UNITED STATES PATENT AND TRADEMARK OFFICE

APPLICATION NO.	FILING DATE	FIRST NAMED INVENTOR	ATTORNEY DOCKET NO.	CONFIRMATION NO.
09/864,925	05/23/2001	Pentti Juhani Eromaki	4447-59072	1687

Office Action Summary

8) **Claims 1-3, 10-24, 31 and 35 are rejected under 35 U.S.C. 103(a) as being unpatentable over Japan '710 (JP 7-40710) in view of Caratta (US 6382283) and optionally Japan '418 (JP 8-244418).**

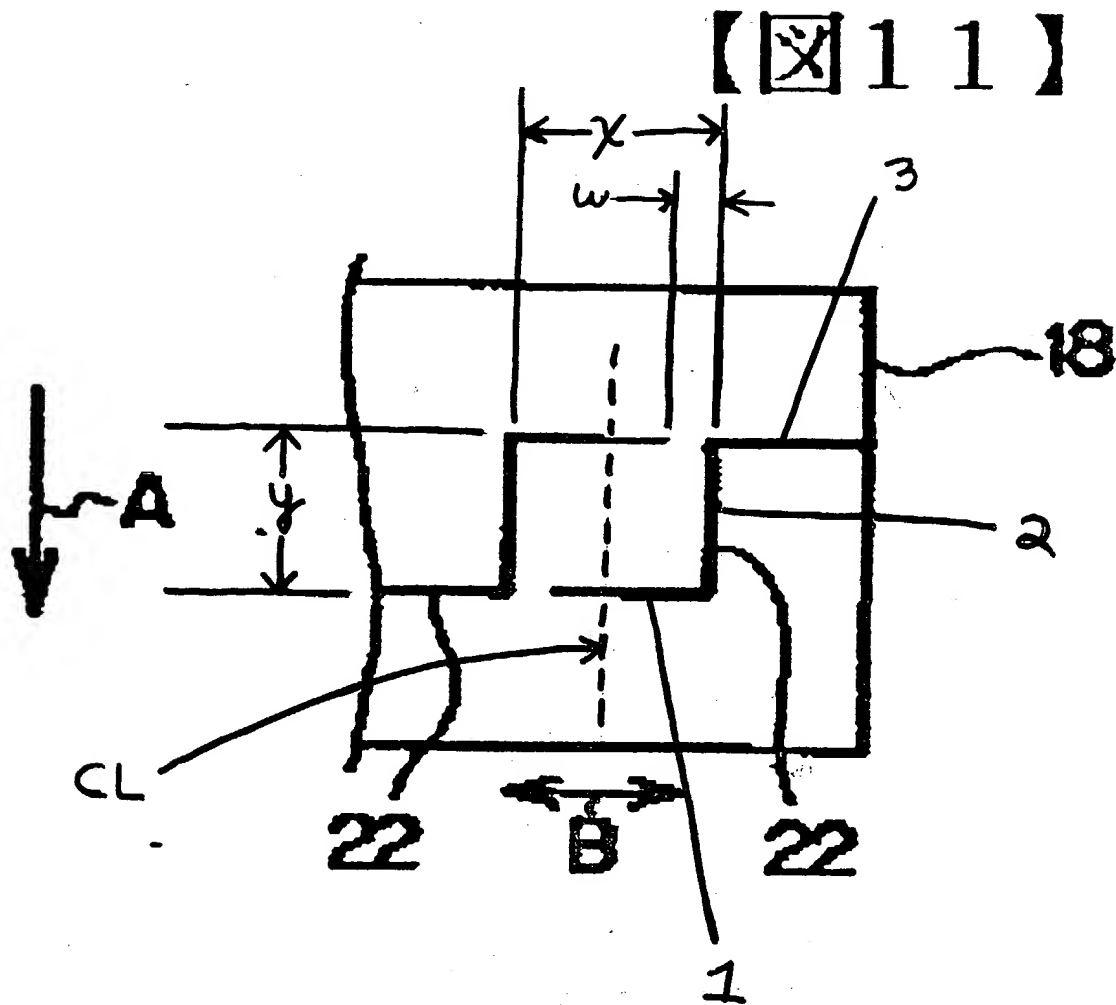
As to claim 1, applicant argues that the prior art does not teach a spacing at most five times the width of the sipes since the shortest spacing of the sipes in Caretta is six times the sipe width and the shortest spacing of the sipes in Japan '418 is eight times the width of the sipes. First: The issue is not the ratio of the "sipe spacing" (the spacing between the sides of sipes) to "sipe width". Instead the issue is the ratio of the "gap spacing" (the spacing between the end of one crank shaped sipe and the bend of another crank shaped sipe) to "sipe width". Second: Caretta and Japan '418 constitute evidence as to what the sipe width and spacings in Japan '710 can and should be. In order to facilitate discussion of the teachings of the applied prior art, an enlarged marked up copy of Japan '710's figure 11 is provided below:

The markings were added by the examiner. In figure 11, the circumferential sipe spacing" is y , the transverse sipe spacing is x and the gap spacing (the width of the web) is w . If the sipe width is 0.5 mm, a gap spacing w of 2.5 mm or less satisfies the claimed limitation of "at most five times". If the sipe spacing x is 4 mm, then the gap spacing w must be less than 2.5 mm since (1) 50% of sipe spacing x is 2 mm and (2) as can be clearly seen from the marked up copy, the gap spacing w is less than 50% of sipe spacing x . As to a sipe width of 0.5 mm, Japan '710 teaches that figure 11 shows

sipes 22 and Caretta and Japan '418 suggest using a sipe width of 0.5 mm for sipes.

As to a sipe spacing of 4 mm, the sides of the sipes 22 in figure 11 are spaced from each other and Caretta and Japan '418 suggest spacing the sides of sipes by a distance for example of 4 mm.

As to claim 23, applicant comments that conventional tires do not have webs whereas claim 23 requires webs which maintain block rigidity. Examiner comments the overlapping crank shaped sipes in Japan '710's figure 11 define a "web" which like that of applicant has a width equal to the small gap spacing and a thickness equal to the sipe width. Since Japan '710's webs have the same structure as applicant's webs, the Japan '710 webs have a decreasing web height as claimed.
